# **Resolution of the Task A-11 Reactor Vessel Materials Toughness Safety Issue**

**Part I - Main Report, Part II - Staff Responses to Public Comments,  
and Appendices A and B**

NUREG-0744  
Vol. 1  
For Comment

Figure 5.1 Schematic Curves of  $J=f(T)$  Illustrating the Material and Structural (Applied) Curves the Intersection Denoting Instability.

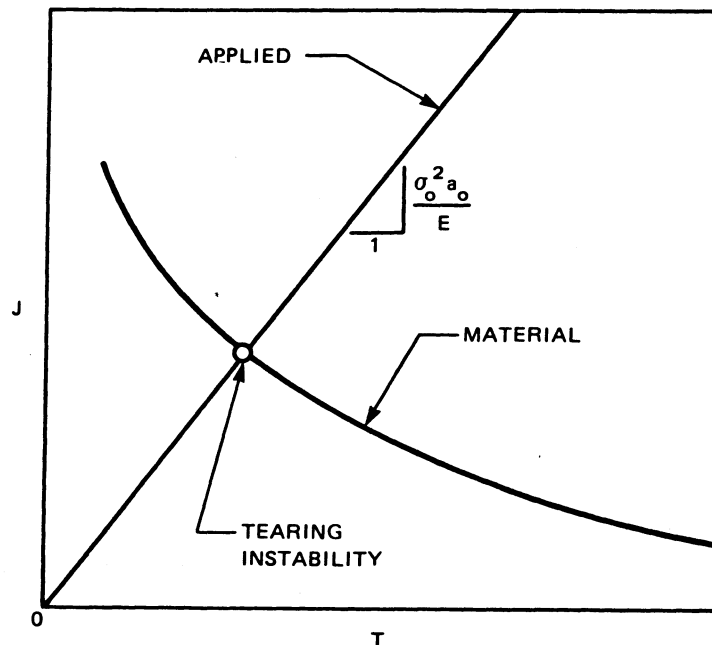
Comment 43: Pg 5-2: Figure 5.1 should show  $J_{IC}$ .  
(Specific)

Resolution: Showing  $J_{IC}$  on Figure 5.1 is not germane to the purpose, which is to illustrate, schematically, the way to determine crack instability (the onset of test fracture) under conditions that can be analyzed with applied elastic-plastic fracture mechanics. In fact, it would be a distraction. Also, the current methods for determining  $J_{IC}$  involve data reduction to obtain two straight lines--the blunting line and a linear representation of the J-R curve between the exclusion lines. The schematic material curve of Figure 5.1 would not accommodate the two straight lines and, at the same time, serve the author's purpose, which is to emphasize the nonlinearity of the J-R curves.

Figure 5.2 J-R Curves From a Low USE A-302B Steel Showing No Size Effect Between 0.5T and 1T CT Specimens at 25°C.

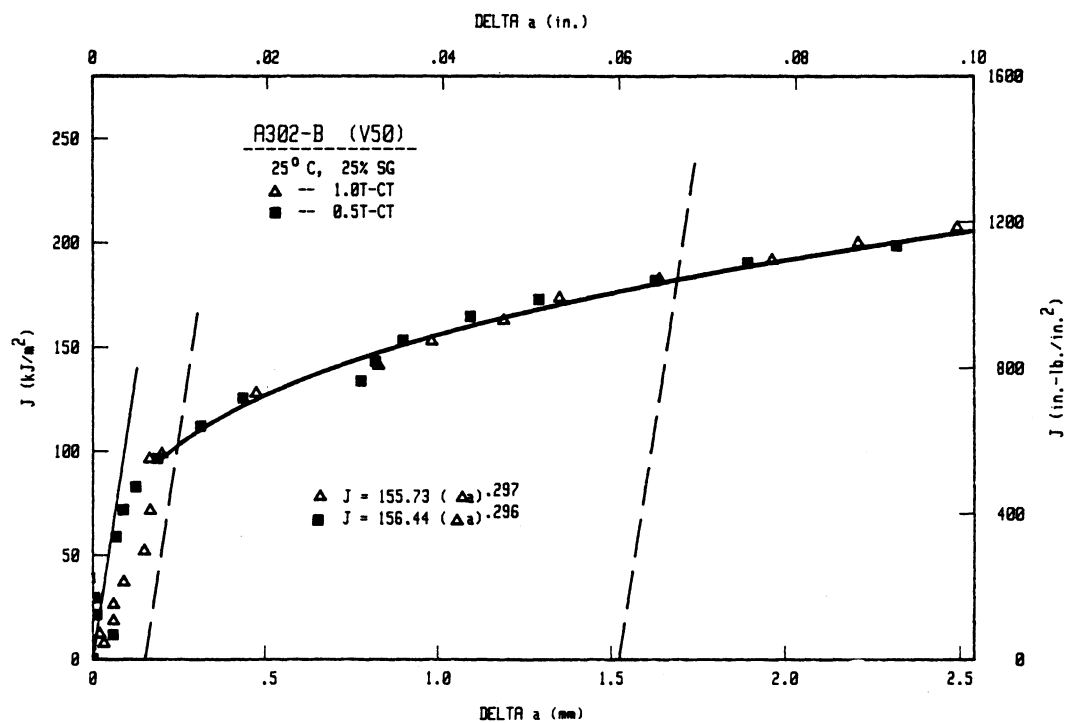
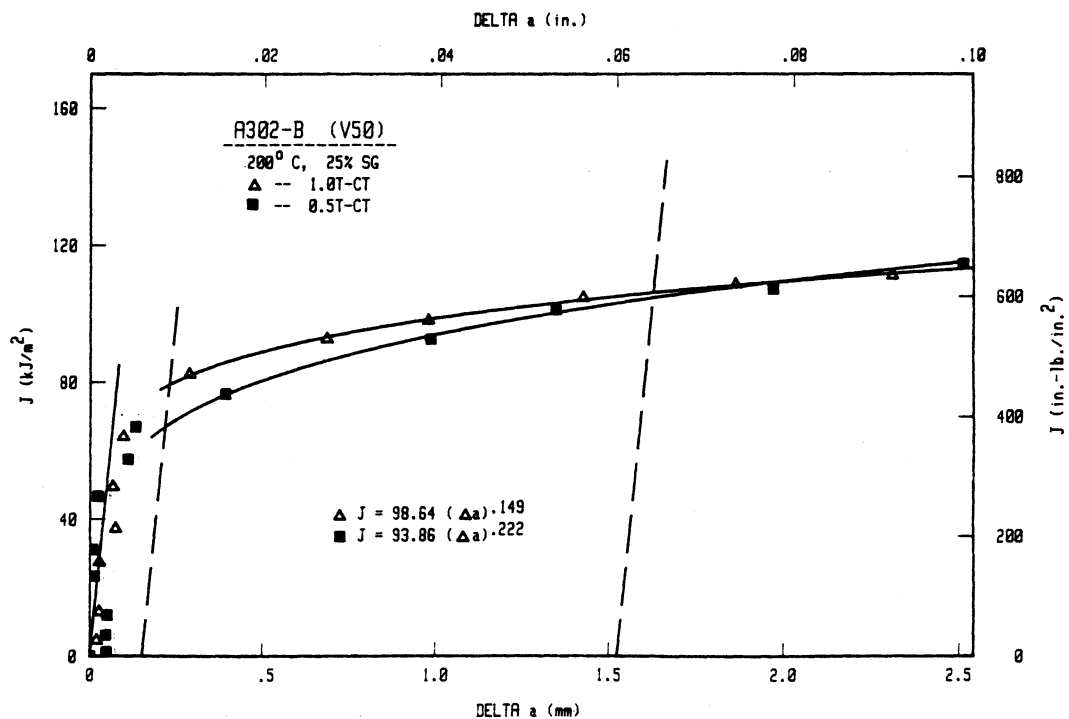
Comment 46: Figures 5.2 and 5.3: These should be credited as NRL data.  
(Specific)

Figure 5.8 HSST Intermediate Pressure Vessels Test Data

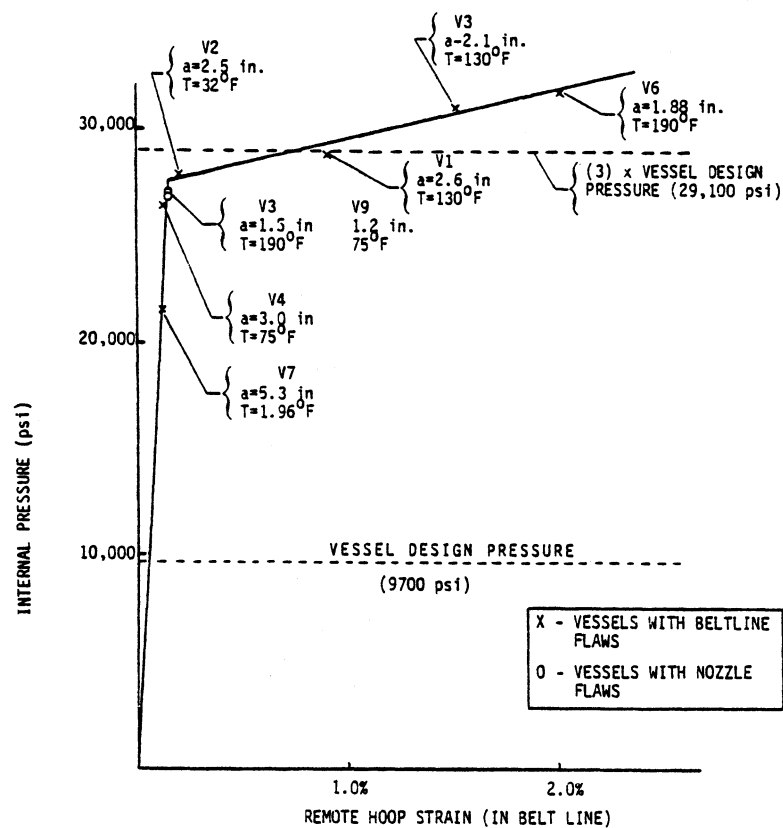
Comment 54: What is the basis of the pressure-strain curve in Figure 5.8?  
(Specific) How does one construct such a diagram for an actual pressure vessel?

Resolution: The  $P-\epsilon$  curve of Figure 5.8 was based on measurements taken at failure of the ITVs noted. It is a reprint of Figure 2, Appendix H. The text accompanying that graph in Appendix H should be read. Because the curve was constructed using data from several vessel

Figure 5.9  $J_{mat}$  Vs.  $T_{mat}$  Curves of Figure 6, Appendix H

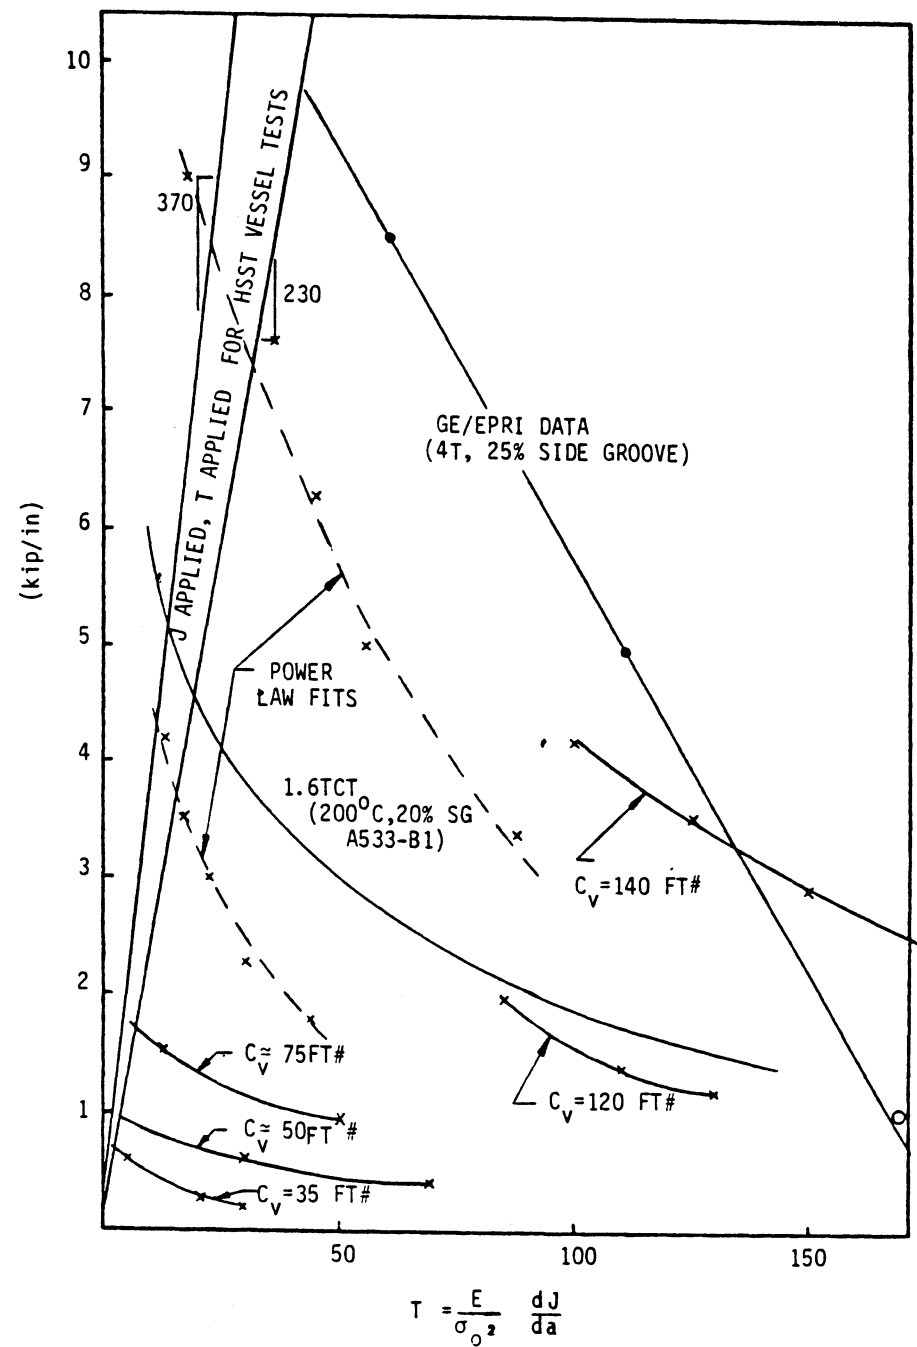
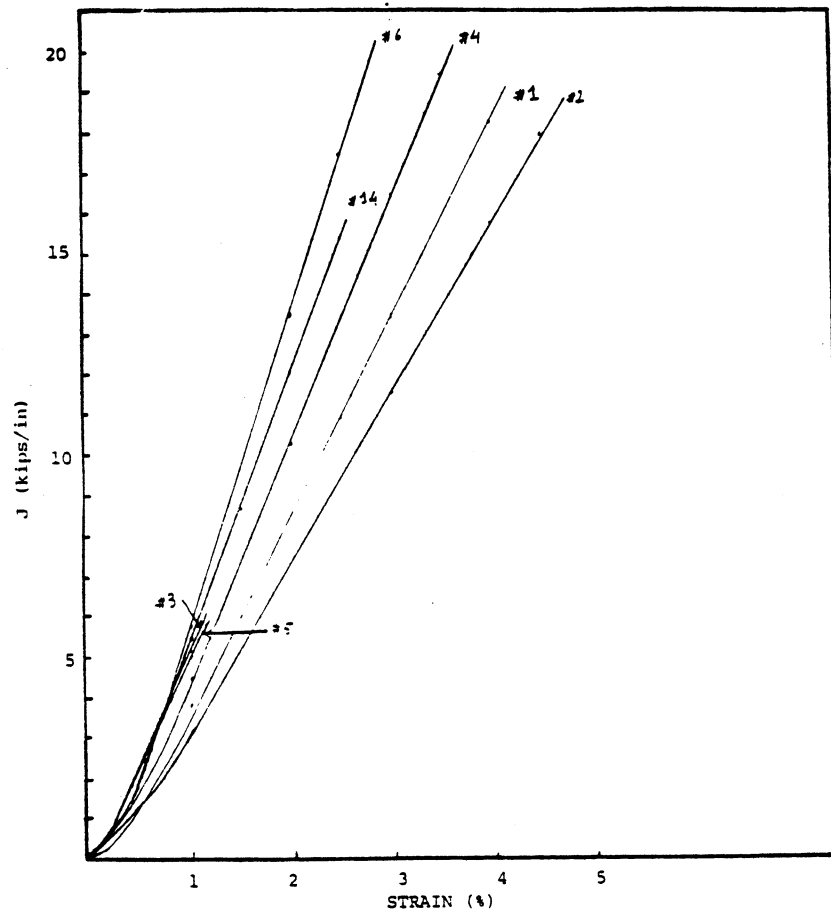
Comment 47: Figures 5.9 and 5.11: The upper line labeled "GE/EPRI Data"  
(Specific) may be too high based on estimates by Loss and Berggren. It should be determined whether the GE experimental data contain a correction for crack extension. This correction will lower the J-R curve. In addition, the NRL data are for 200°C. It is known that the R curve falls with rising temperature. This fact is not mentioned in the comparison with vessel tests.

Figure 5.12  $J$  Vs.  $T$  Curves for the Large Tensile Specimens Corrected for Plane Stress

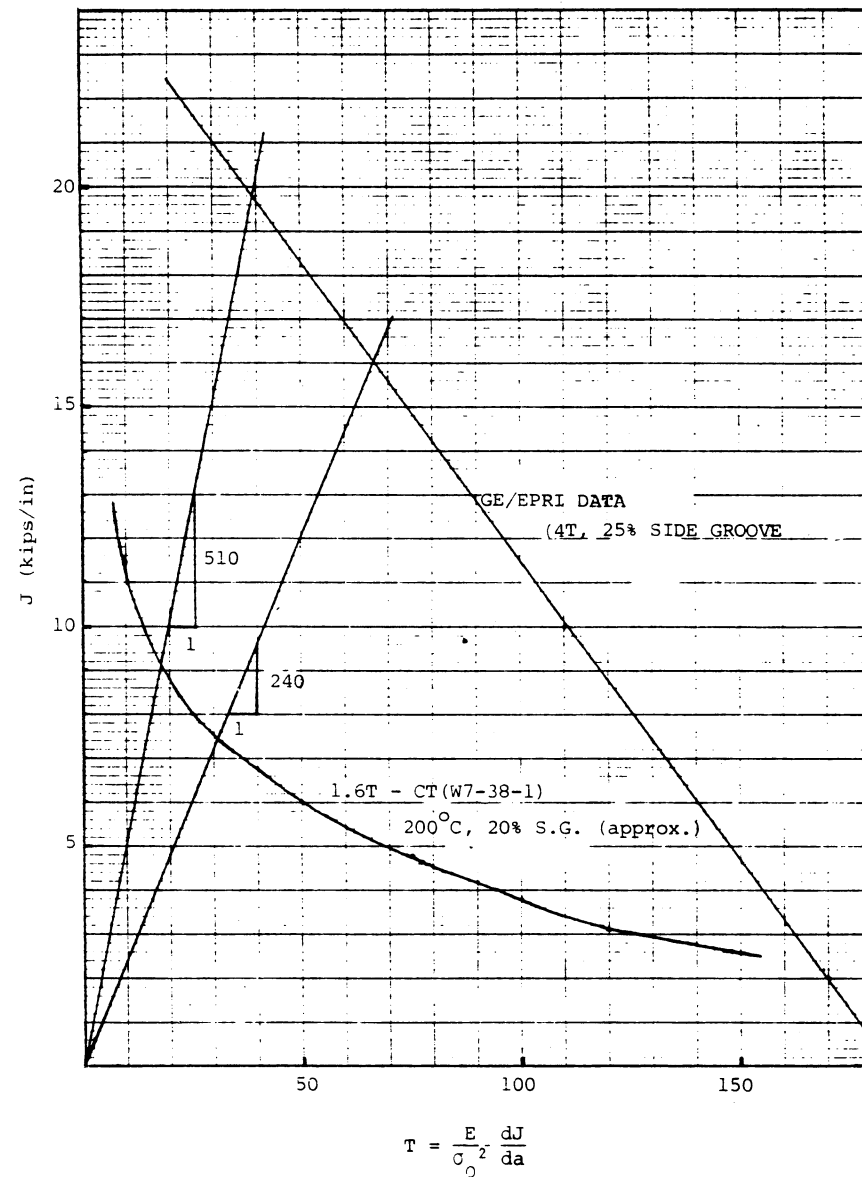
Comment 48: Pg 5-18: What is a "coupled J value"? Where is it shown on  
(Specific) Figure 5.12?

Figure 5.13 Correlation between  $J$  (at the intersection of the  $J/T = 50$  in.-lb/in.<sup>2</sup> load line and a materials curve) and the corresponding Charpy upper shelf energy value

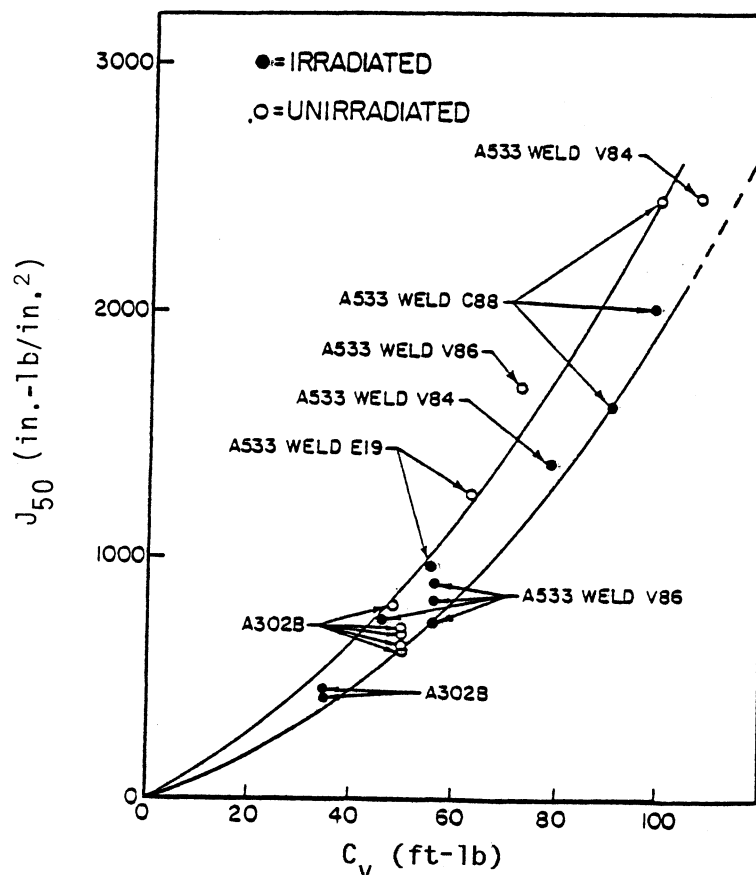
Comment 9c:  
(General) Pg 5-21 and Figure 5.13: NRL should be credited for the original concept of a  $C_v$ -J correlation. Note that the correlation applies only at 200°C and that the R curve varies inversely with temperature. A more up-to-date correlation is Figure 11 of the ASTM Philadelphia paper by Loss or Figure 14 of the NRC information meeting.

Comment 49: Pg 5-22, Figure 5.13: Is this the preferred figure or should  
(Specific) Figure 14 on pg D-23 be used? The latter was used in Appendix I. In the title to this figure, the words following "correlation" should be deleted.

Comment 50a: The units for J in Figure 5-13 are wrong. The implications of  
(Specific) this figure should be discussed in some depth, because it appears to be a key figure with regard to the proposed analysis.

Resolution: The graph shown on pg 5-22 of NUREG-0744 is the one intended for Figure 5.13. It is not clear what was meant by the idea of "preferred" in the question. The lower bound correlation that is preferred as a part of an RPV analysis at any point in time will be that which is based on the most extensive collection of accurate, relevant data. The sentence on pg 5-22 that precedes Figure 5.13 addressed that point. The figure title has been changed.

Resolution: The problem with the units is a typographical error. It is believed that there is enough discussion of the implications of Figure 5.13, when all the discussions in the appendices are considered.

Figure 14 An attempted correlation of  $J_{50}$  values with Charpy upper shelf values from data by Loss

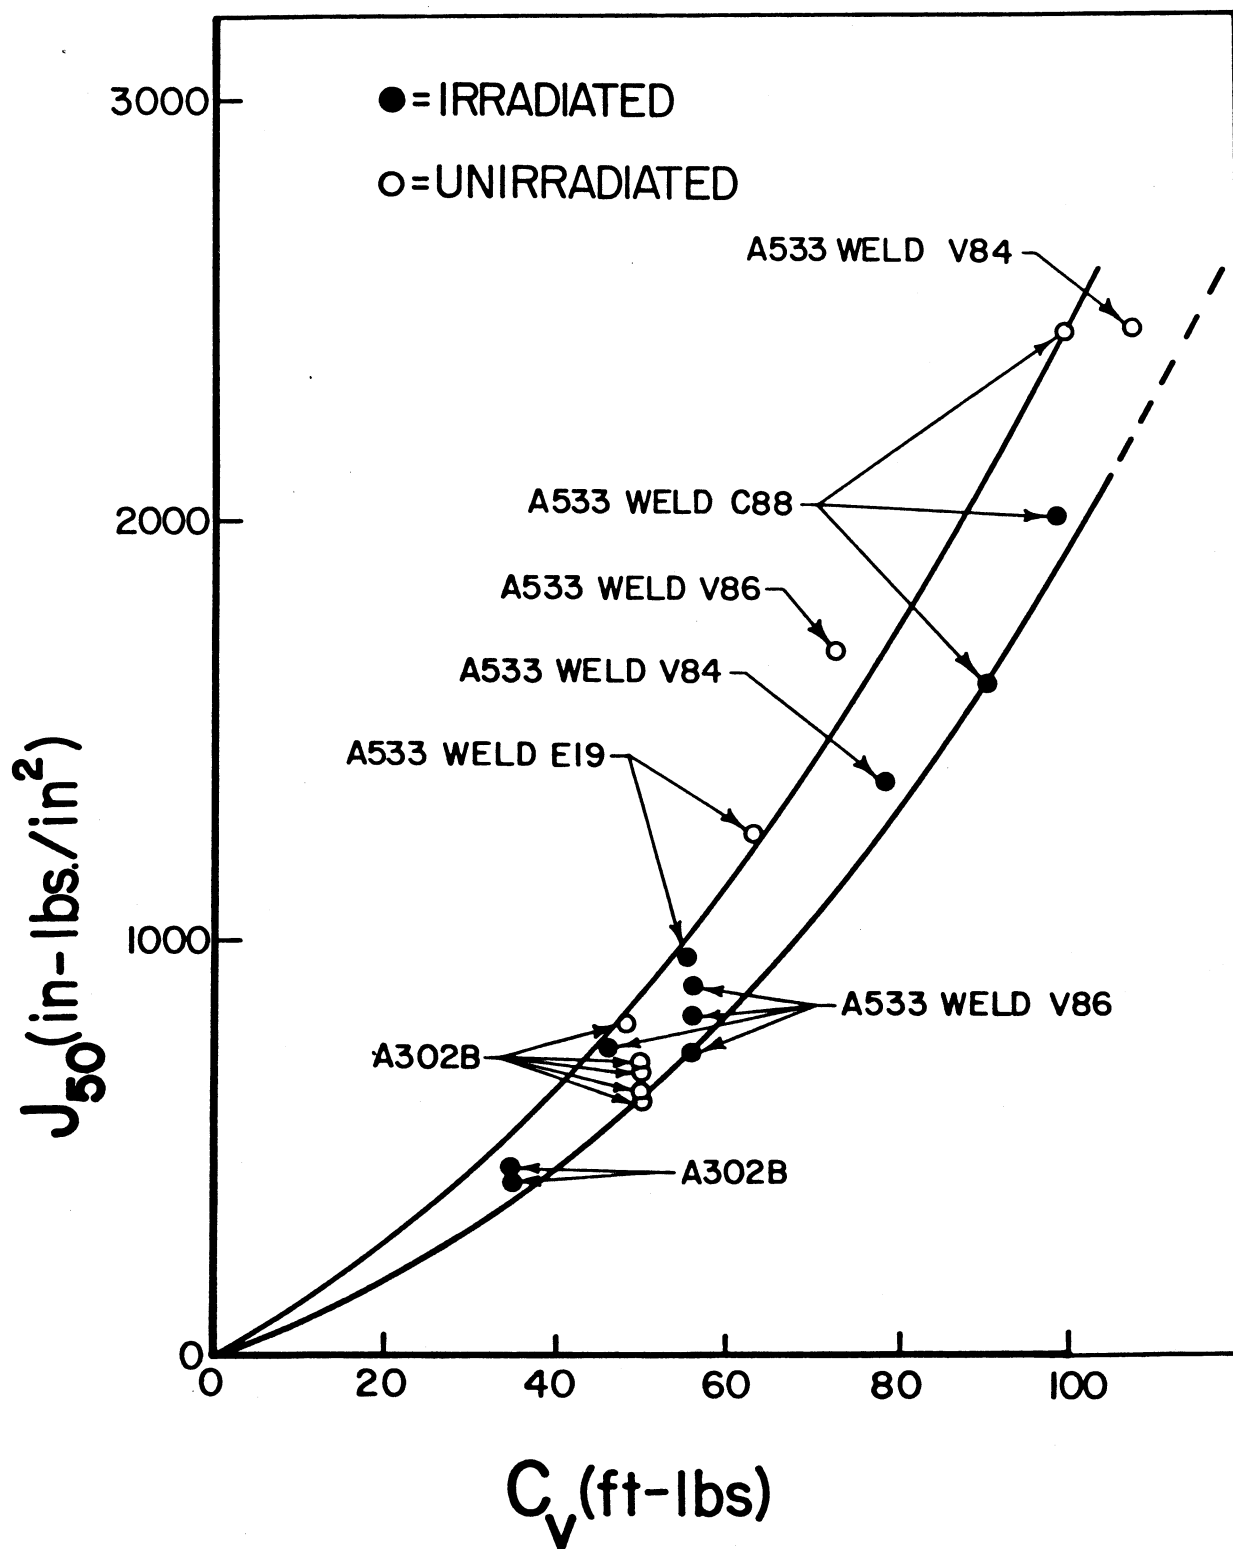
- o Absent plant-unique property curves, "the lower bound J (at  $J/T = 50$ ) =  $f(\text{USE})$  curve" is to be used. Which of the two different curves in the NUREG is preferred (Figure 5.13 or Figure 14 on pg D-23)?
